**NUMBER:** 23-043-02

Sunshade May Partially Close During Hard Application Of The Service Brakes

This bulletin involves the replacement of the four sunshade guide blocks and springs.

2002 (WJ) Grand Cherokee  
2002 (WG) Grand Cherokee (International Markets)

**Fig. 1 SUNSHADE GUIDE BLOCK AND SPRING**

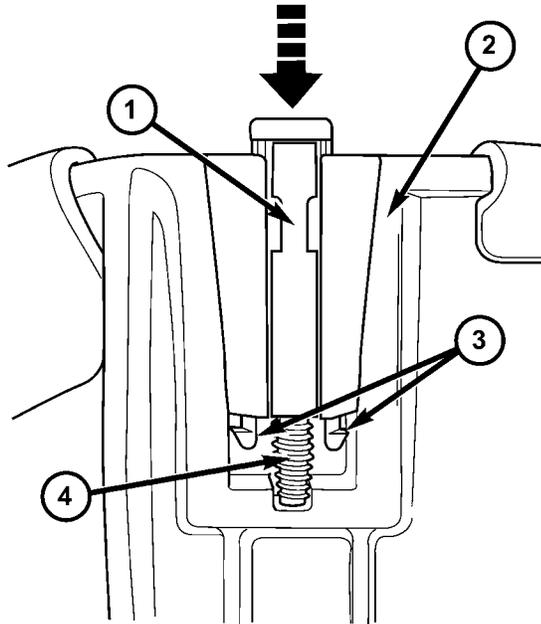
During a hard application of the vehicle service brakes, the customer may notice that the sunshade has slid forward from its fully open position to a partially closed position.

8. Disengage the rear guide blocks from the sunroof track.
9. Replace all four sunshade guide blocks and springs. Compress the guide block locking tabs to remove the old block and spring (Fig. 1).

**NOTE: MAKE CERTAIN THAT BOTH GUIDE BLOCK AND SPRING ARE REPLACED.**
